The application requests that the Davis-Besse Nuclear Power Station Unit No. 1 Technical Specifications be revised to reflect the changes to the appropriate figures and tables due to the incorporation of the actual Reactor Coolant Pump coastdown characteristics.

APPLICATION FOR AMENDMENT  
TO  
LICENSE NO. NPF-3  
FOR  
DAVIS-BESSE NUCLEAR POWER STATION  
UNIT NO. 1

REQUESTED CHANGE TO  
THE DAVIS-BESSE NUCLEAR POWER STATION  
UNIT NO. 1  
TECHNICAL SPECIFICATIONS  
(Appendix A to License No. NPF-3)

Figure 2.1-2 Reactor Core Safety Limit

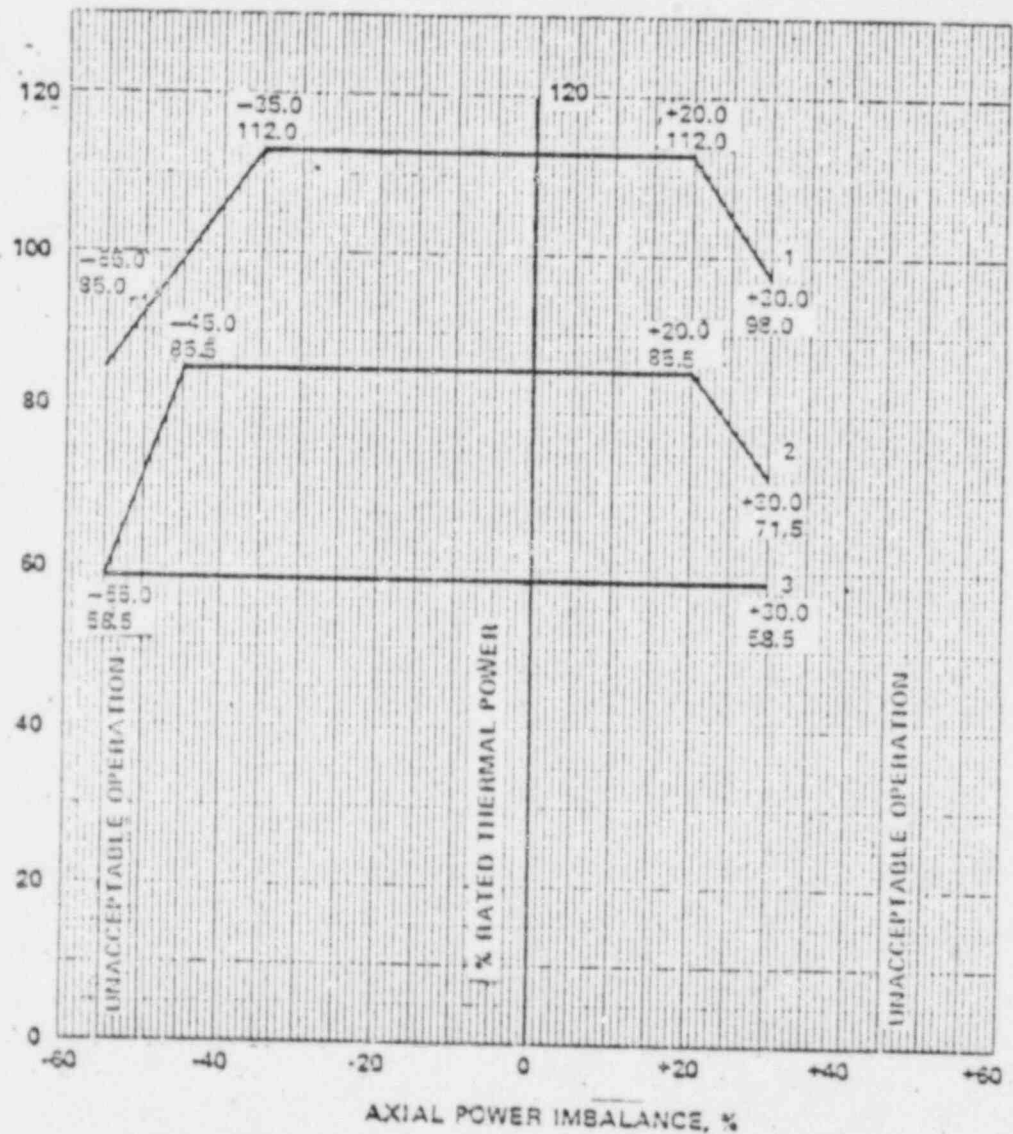
The following attached pages have been modified to show the requested changes:

CURVE	REACTOR COOLANT FLOW (GPM)
1	387,200
2	290,100
3	191,000

Figure 2.2-1 Trip Setpoint for Flux- $\Delta$ Flux-Flow

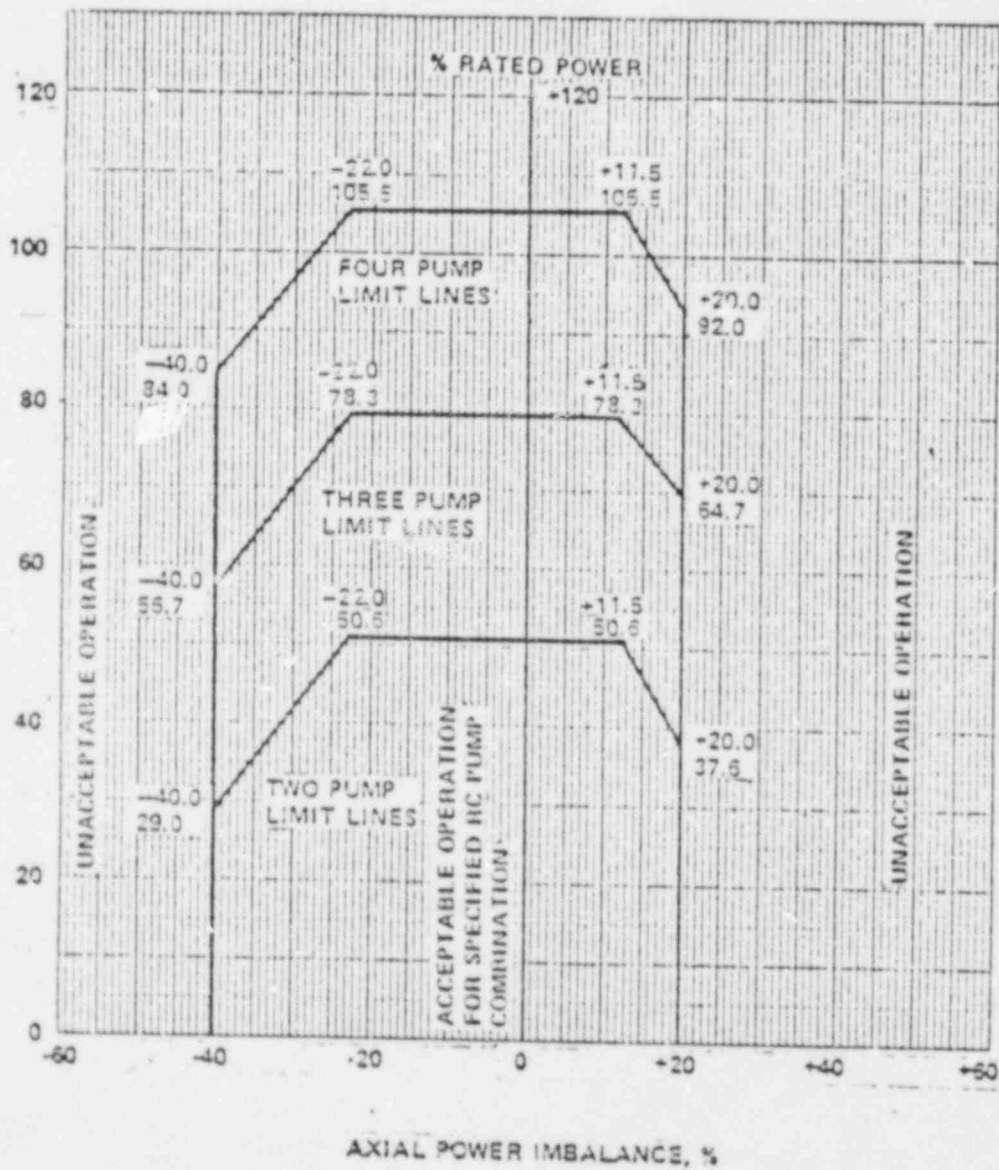
3. RC High Temperature	< 619°F	< 619.08°F#
4. Flux - Δ Flux-Fixed (1)	Trip Setpoint not to exceed the limit line of Figure 2.2-1.	Allowable Values not to exceed the limit line of Figure 2.2-2.
